CITY OF ALBUQUERQUE

Re: Ceja Vista Apartments/ PHASE 1
10001 Ceja Vista Rd. SW
Request for Certificate of Occupancy
Transportation Development Final Inspection
Architect's Stamp dated 11-25-19 (P09-D002G)
Certification dated 05-04-23

Based upon the information provided in your submittal received 05-11-23, Transportation Development cannot approve the release of Certificate of Occupancy for the above referenced project.

RE: Ceja Vista
10001 Ceja Vista Road SW
Zone: R2
Submittal: TCL for Final C.O. of Phase 1

NORTH
A1
SITE PLAN
1" = 50'-0"

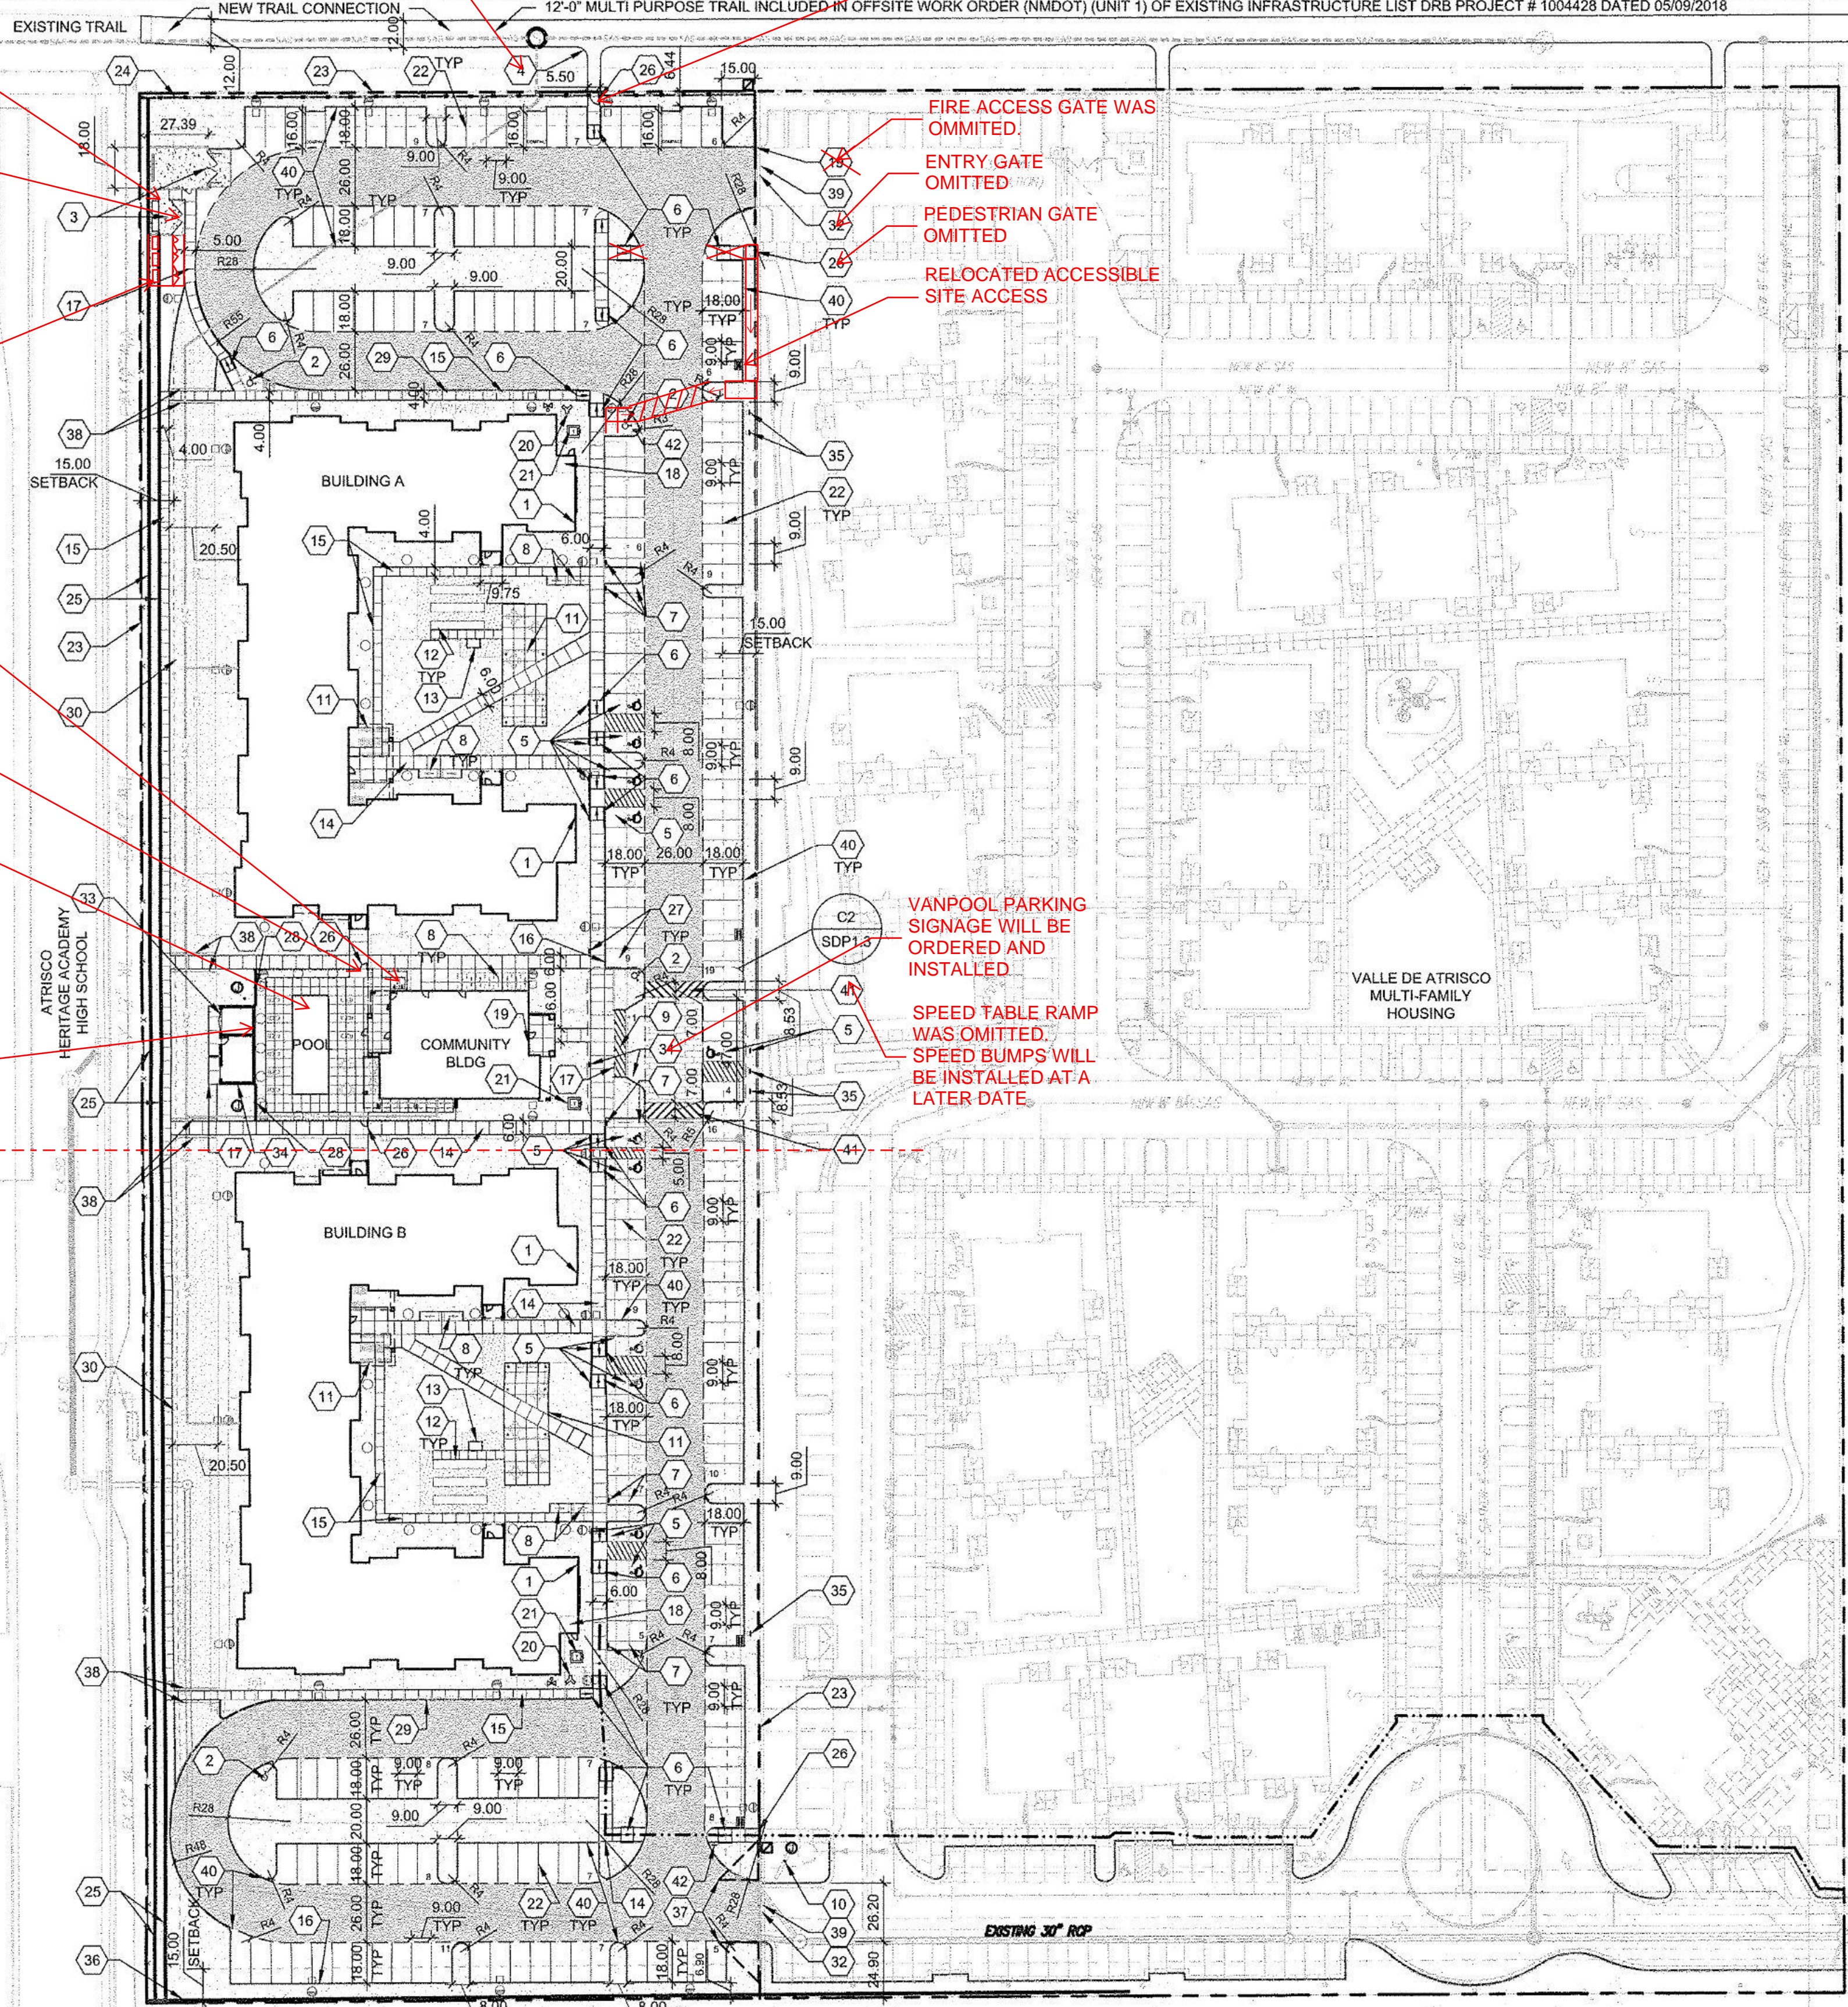
- Keynote 4: Per site visit pedestrian pathway from the north side Trail, is missing. And pedestrian gate is missing too.
- Per site visit, the width of the pathway at the west side of the Trash Enclosure is 3.5 ft. But the Approved site plan shows 5 ft. wide pathway. Please provide 5 ft. wide path way.

- Pathway striping at the east side of the Community Building is missing.
- Please install the Vanpool parking sign.
- Van accessible aisles should be 8ft wide.

- Fire access gate was omitted during construction. Knox Box no longer required at this location.
- Pedestrian gate is on order and will be installed upon its arrival.

- Walkway connection to Dennis Chaves Blvd. will be installed following the installation of the pedestrian gate.
- ADA access route was revised and red lined on plan.

- 2 sidewalk ramps were omitted per changes in the ADA access route.
- Block wall at Trash Compactor is in progress. It is currently at 6'-8" and the final height is 9'-4".

- Gates at Trash Compactor and Enclosure are on order.
- Trash Enclosure was revised to accommodate 5 trash bins from 2 bins. Changes have been approved by Solid Waste and COA.

- Pool and outdoor showers were omitted during construction. Artificial turf and a shade structure were installed in place of the pool.
- Fence around opens space has been revised but is not yet installed.

- Building mounted lights are not yet installed.
- Van Pool Parking signage is missing but will be ordered and installed.
- Speed table and stamped concrete were omitted during construction. Speed bumps will be installed at a later date.

WALKWAY WILL BE INSTALLED FOLLOWING PEDESTRIAN GATE INSTALLATION

PEDESTRIAN GATE IS ON ORDER AN WILL BE INSTALLED UPON ITS ARRIVAL

FIRE ACCESS GATE WAS OMITTED.

ENTRY GATE OMITTED

PEDESTRIAN GATE OMITTED

RELOCATED ACCESSIBLE SITE ACCESS

VANPOOL PARKING SIGNAGE WILL BE ORDERED AND INSTALLED

SPEED TABLE RAMP WAS OMITTED. SPEED BUMPS WILL BE INSTALLED AT A LATER DATE.
